ADDENDUM 2

SUBJECT: SAPD Academy Track Pavement, (ID No.: 23-04058), Date of Issue: Friday, August 1, 2025, Scheduled to Close: Tuesday, September 16, 2025

THIS NOTICE SHALL SERVE AS ADDENDUM NO. 2 – TO THE ABOVE REFERENCED INVITATION FOR BIDS

C11.0

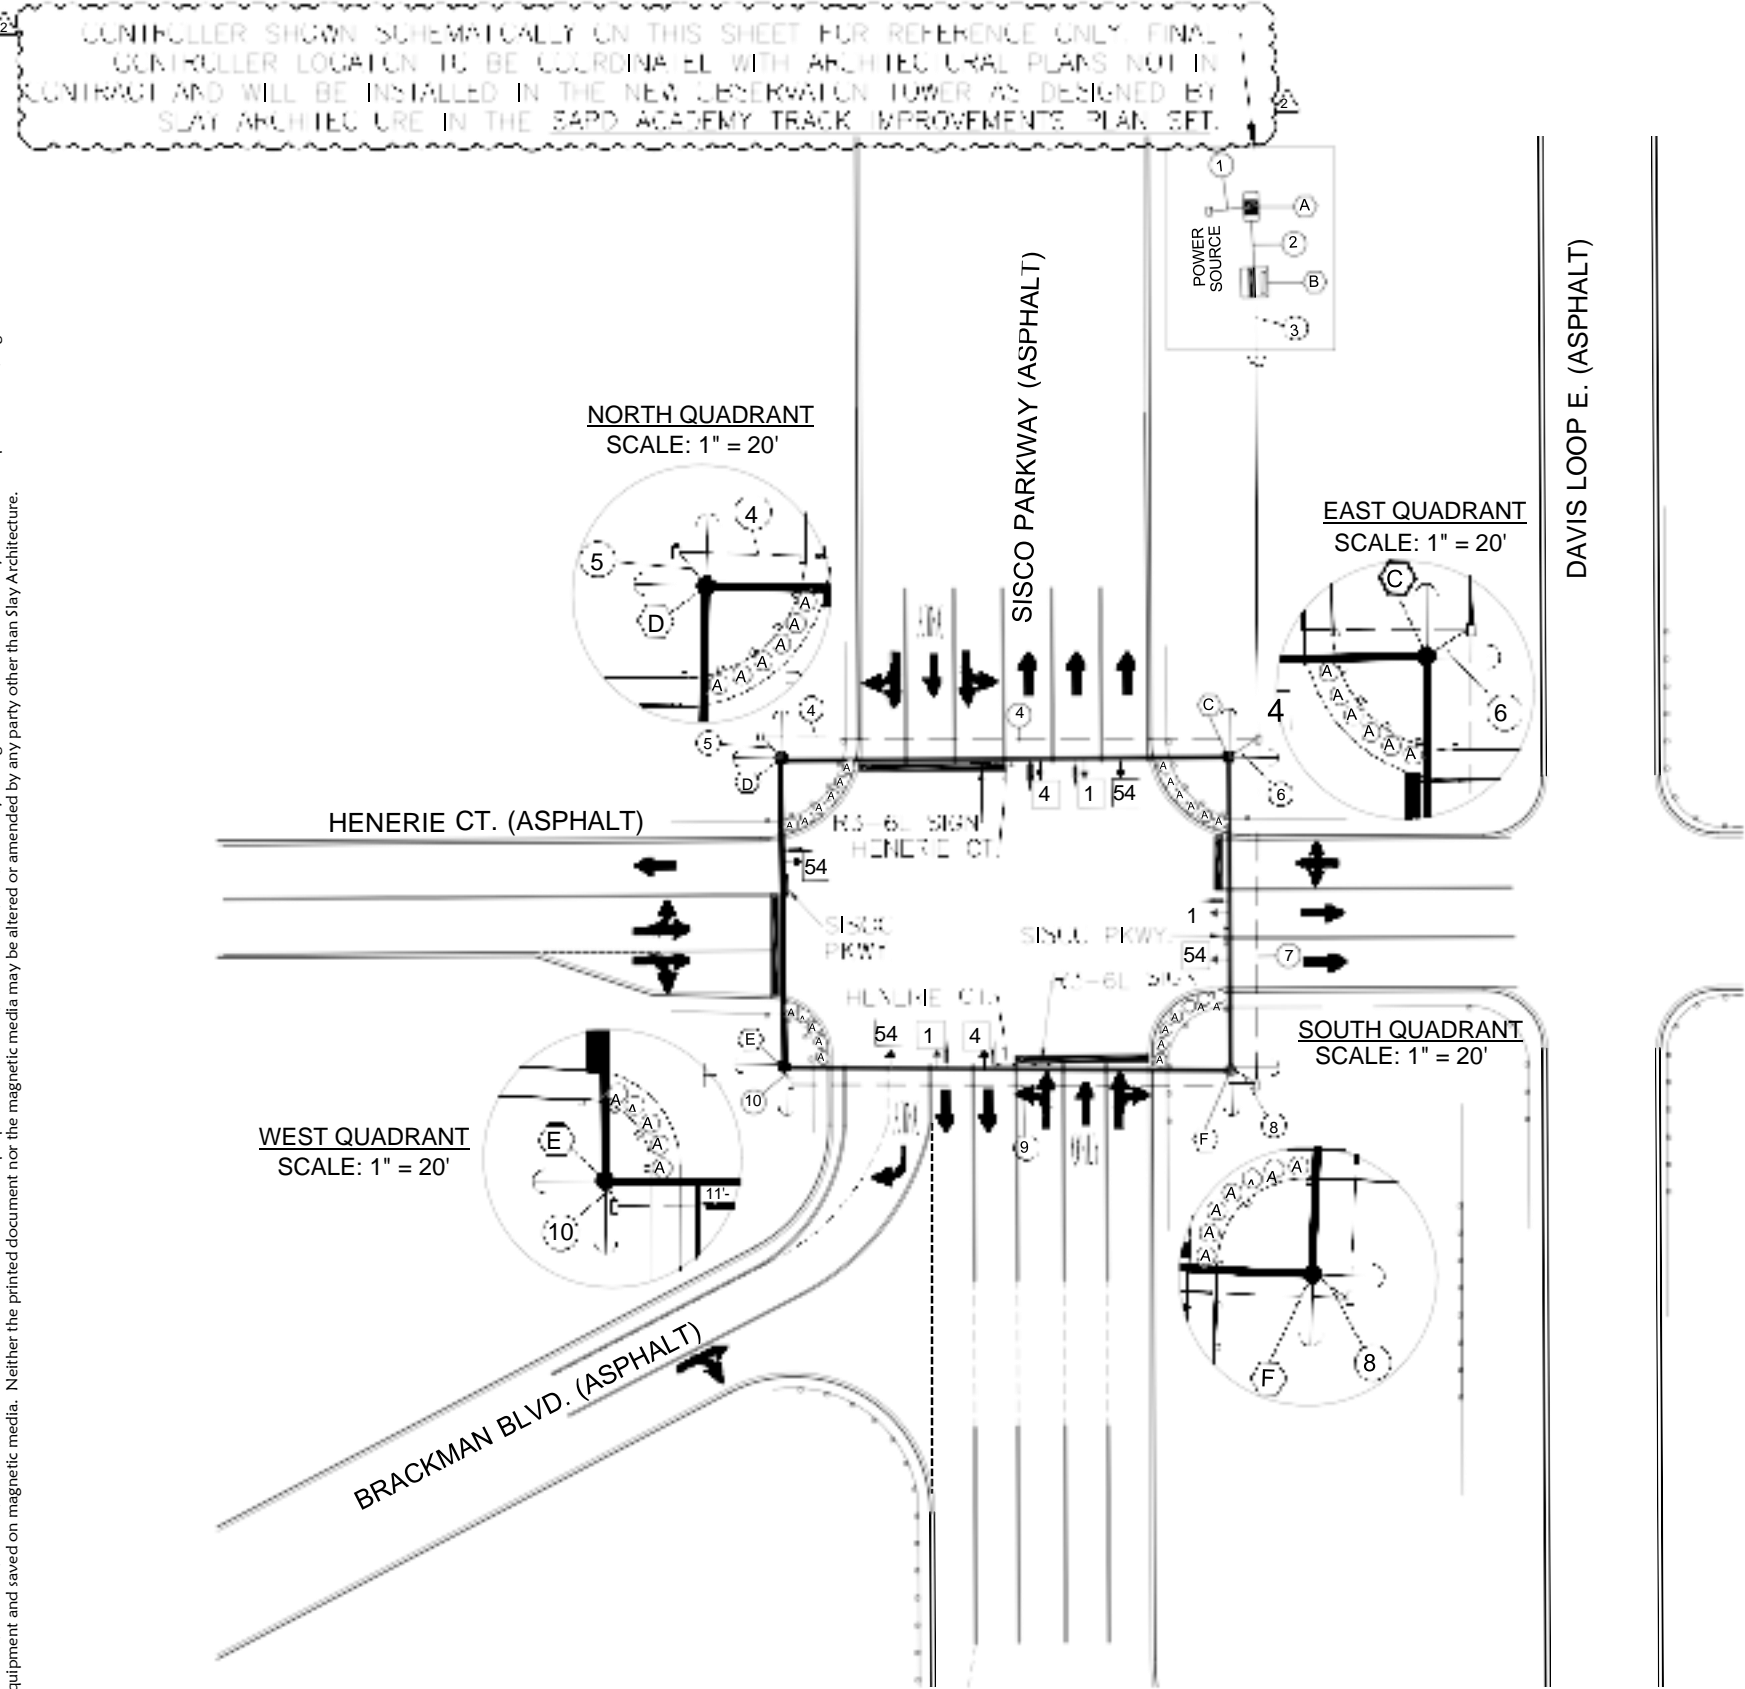
Question 22: Traffic signal plan notes say to see C12.0 for conduit to observation tower. C12.0 shows a cross section of the road, and no conduit runs for the signal.

1. Remove the following sheets and replace them with the attached revised sheets:
C0.0 – Cover Sheet
C11.0 – Conduit Sleeves and MBGF Plan – Added notes for clarification and coordination with new observation tower.

Response: Sheet C11.1 has been revised for clarity. See sheet C11.0 for the conduit run to the observation tower.

C11.1
TRAFFIC SIGNAL

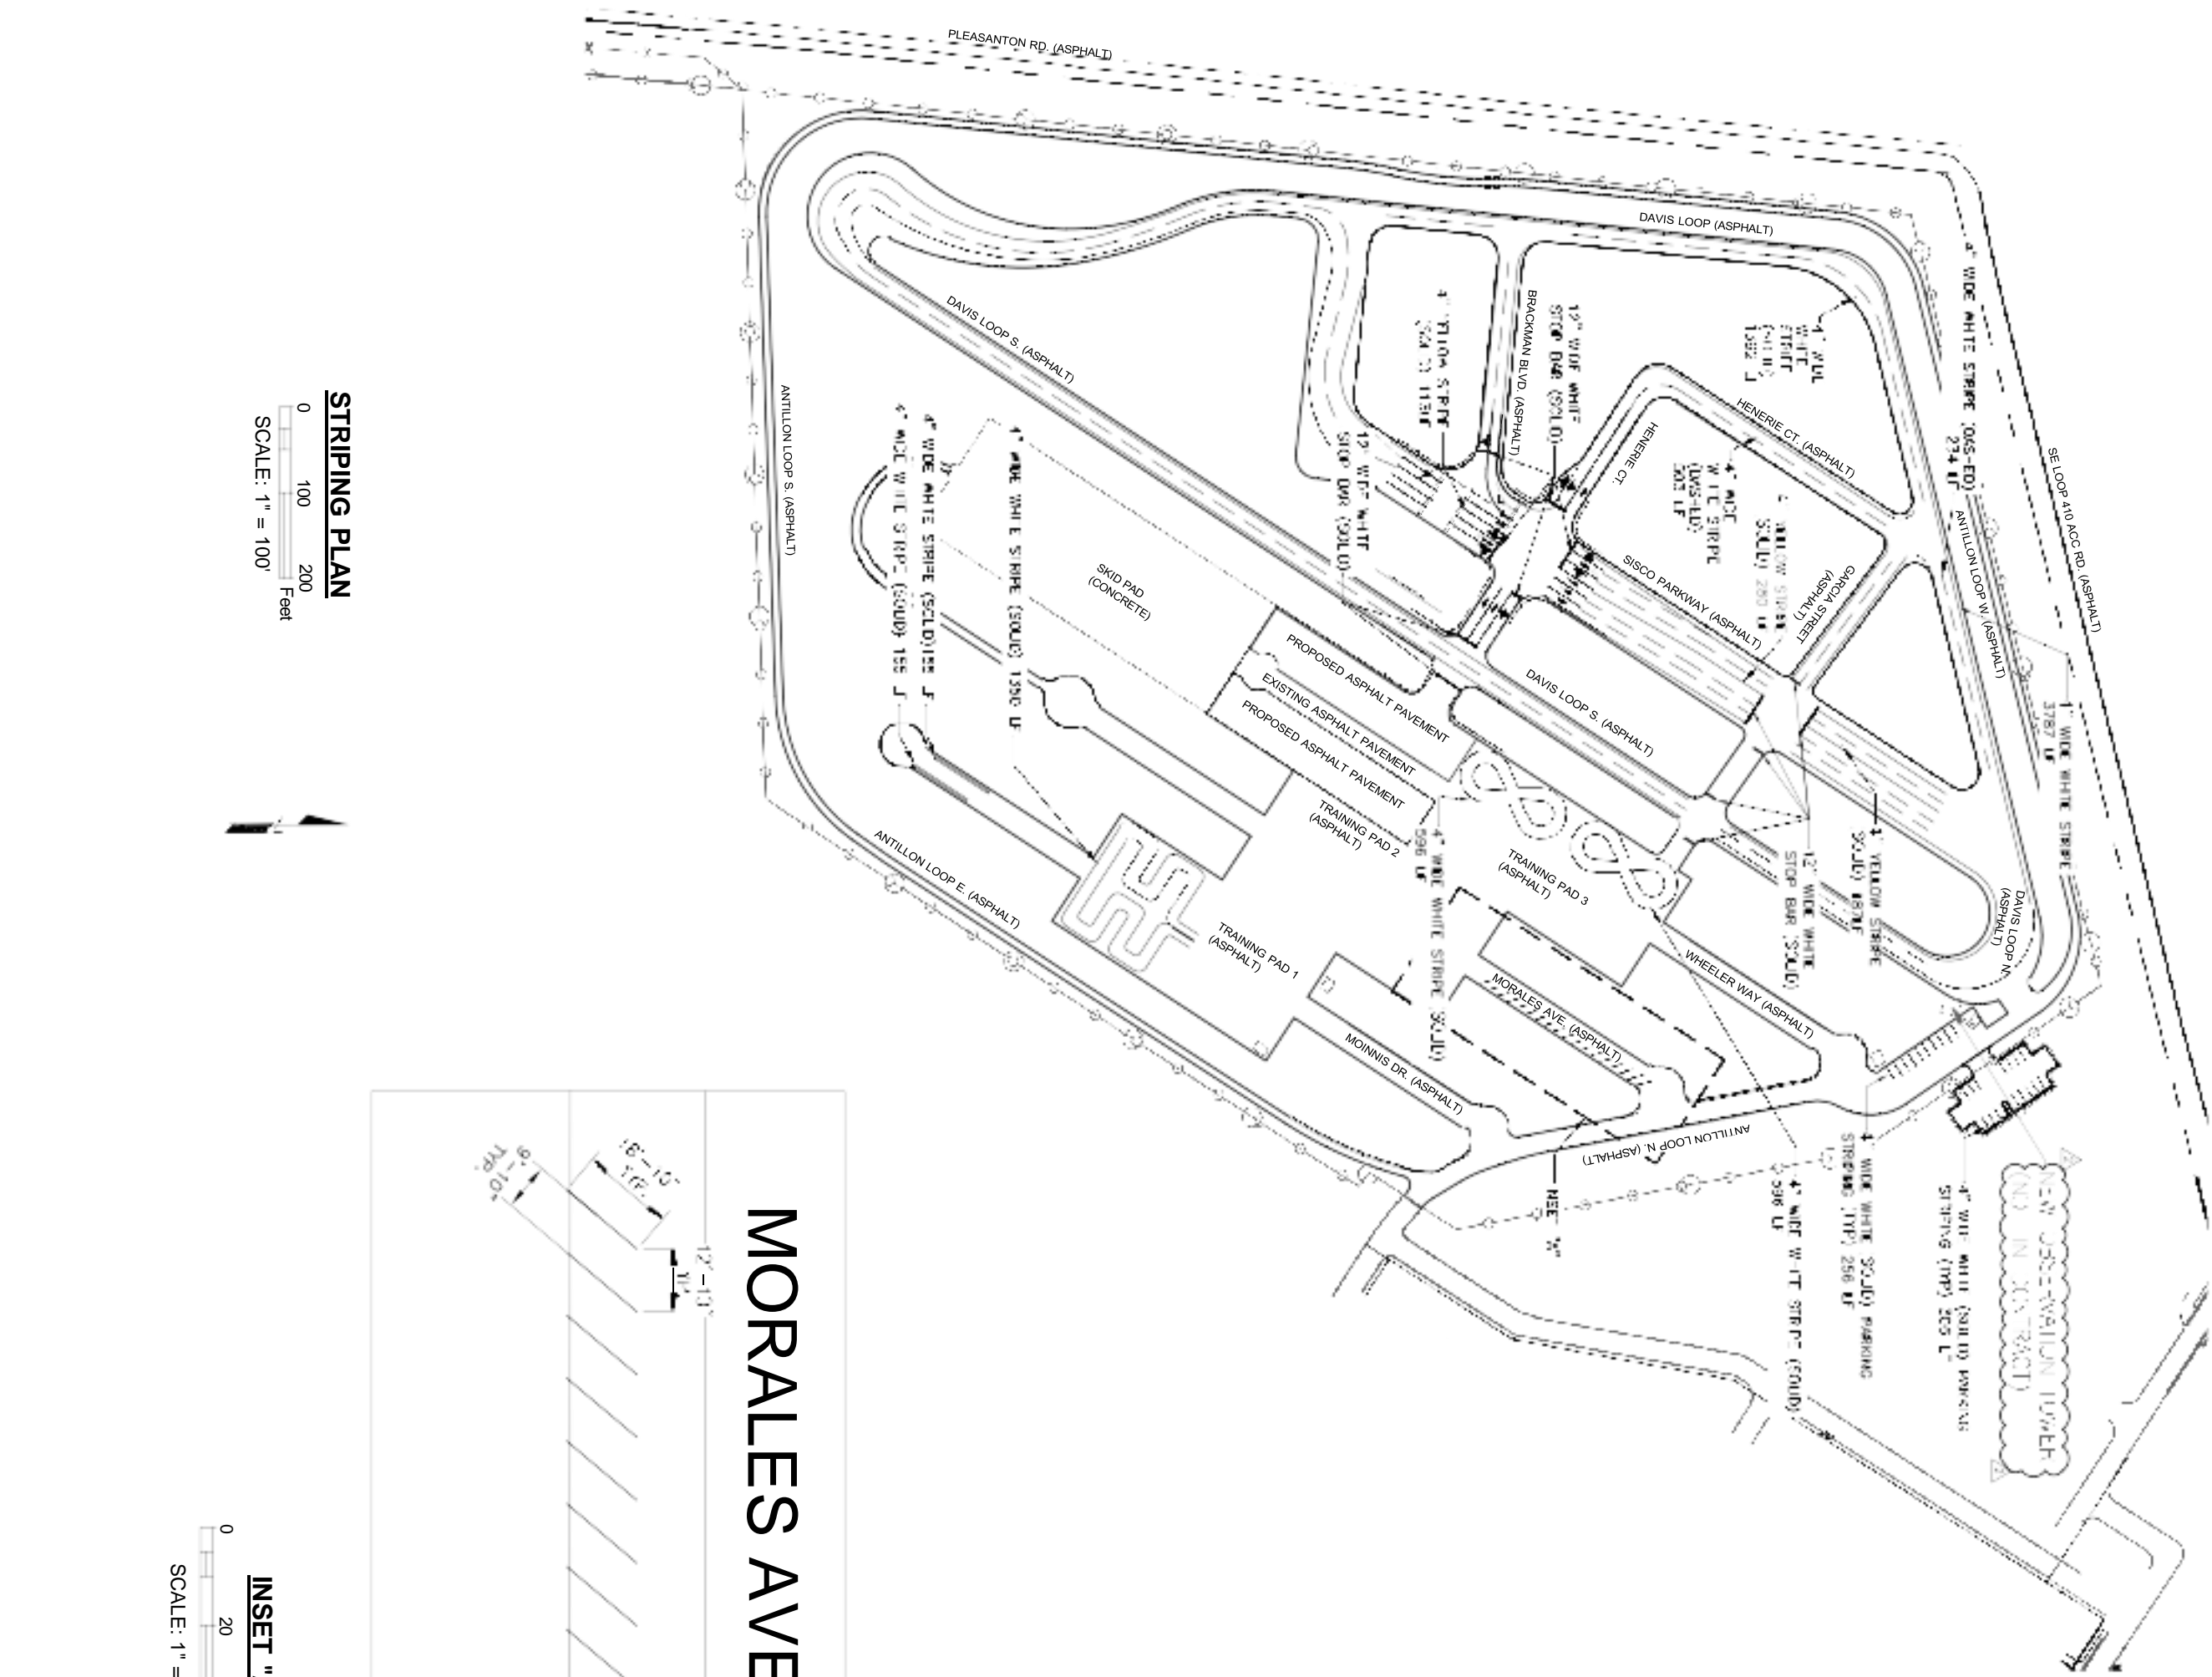
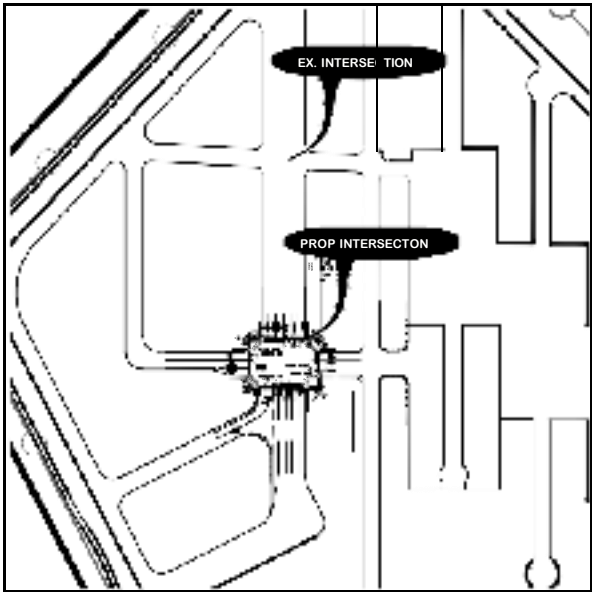
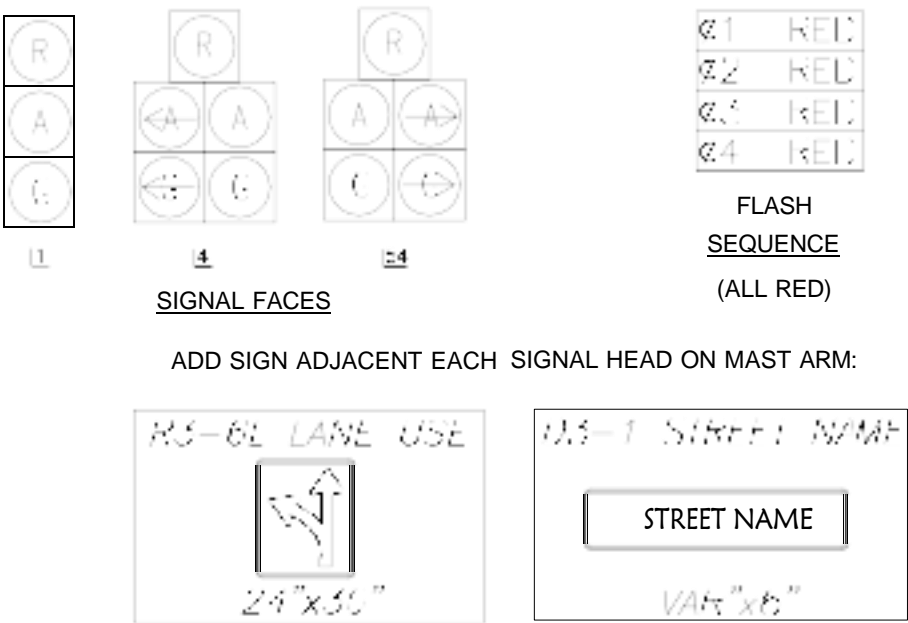
Question 21: For traffic signal work, why are you running conduit in the ground when this is a wood pole intersection, and everything will be run overhead? The plans state controller and cabinet will be located in the observation tower, but the plans show it to be installed next to the intersection. Will detection need to be provided at the intersection? If so, what type? Who will be responsible for programming the controller?

C11.1 - Traffic Signal - Added notes for clarification and coordination with new observation tower.

Response: Conduit is included at the new signalized intersection to accommodate future lighting additions not part of this contract. The controller and cabinet are to be located at the observation tower as clarified on Sheet C11.1 (see also Sheet C11.0 for conduit run). No vehicle detection is required or included under this contract. The training signal will operate pre-timed. Owner will provide the timing/phasing parameters. The Contractor shall load the provided program into the controller and perform functional testing with the Owner.

STRIPING PLAN
0 100 200
Feet
SCALE: 1" = 100'

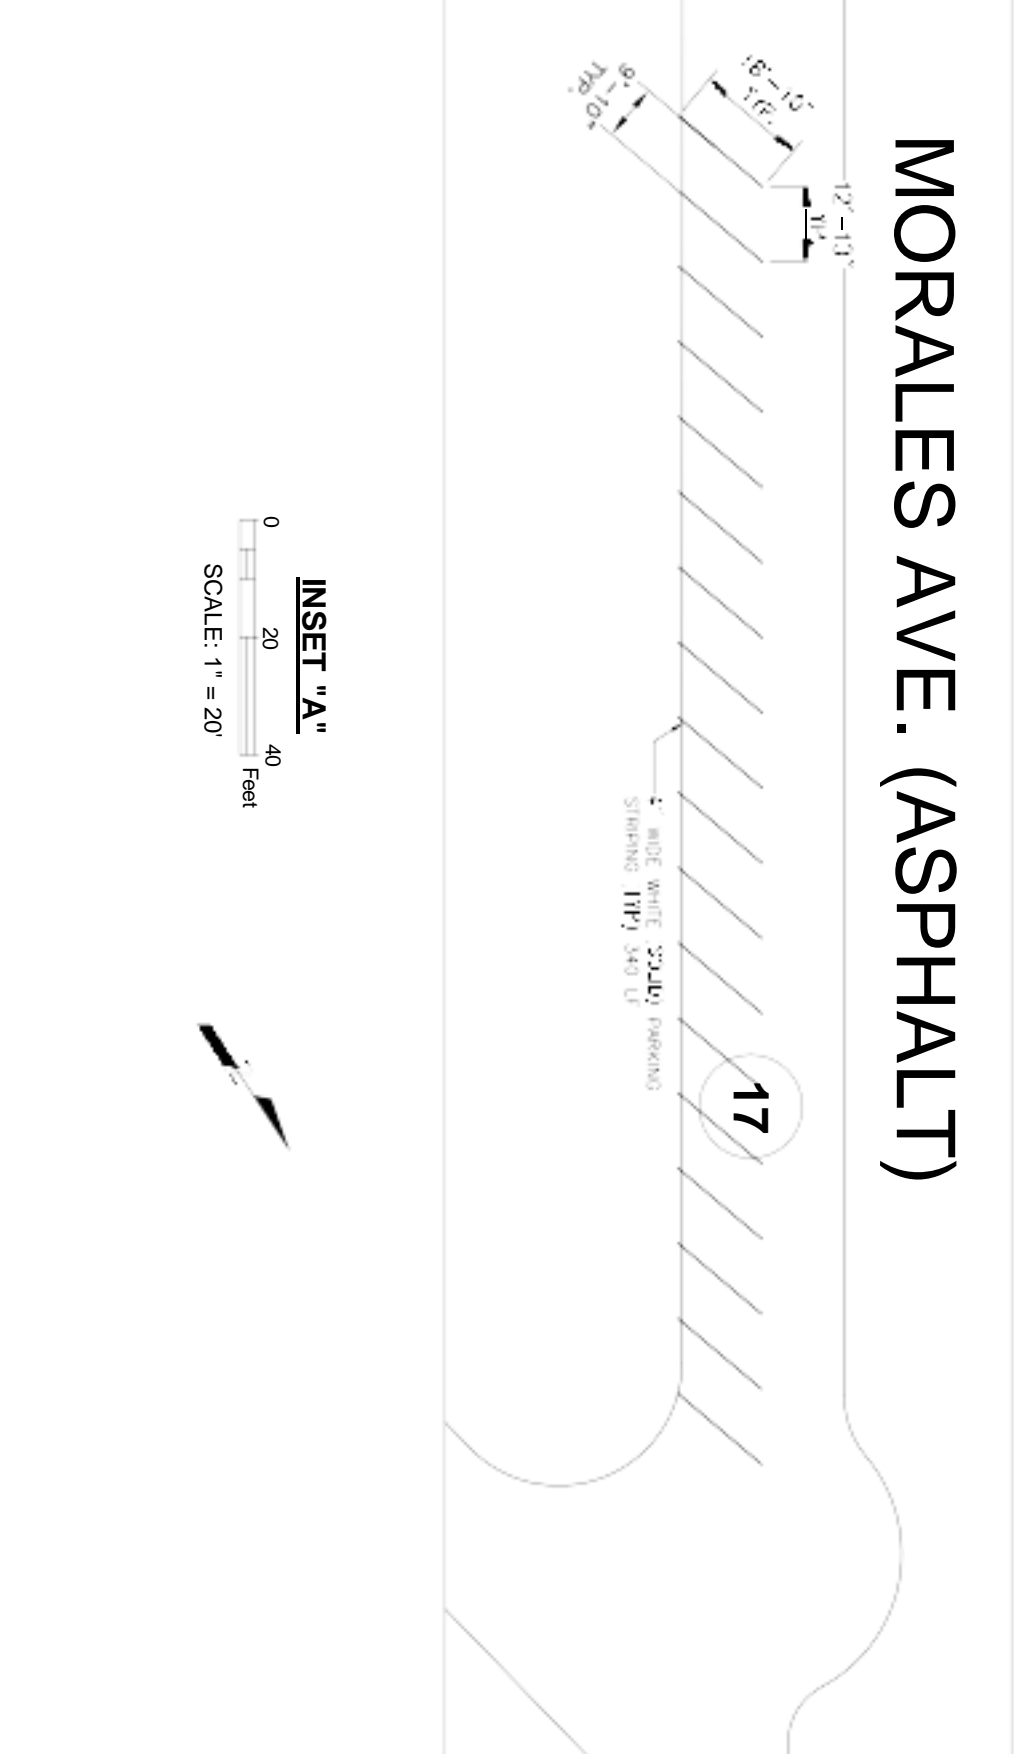
Question 31: Pavement markings state typical please verify that it is same for entire project and not thermoplastic.

C11.2 - Striping Plan - Added notes for pavement striping clarification.

Response: All stop bars shall be thermoplastic. Track lane striping shall be thermoplastic per project specifications. See sheet C11.2
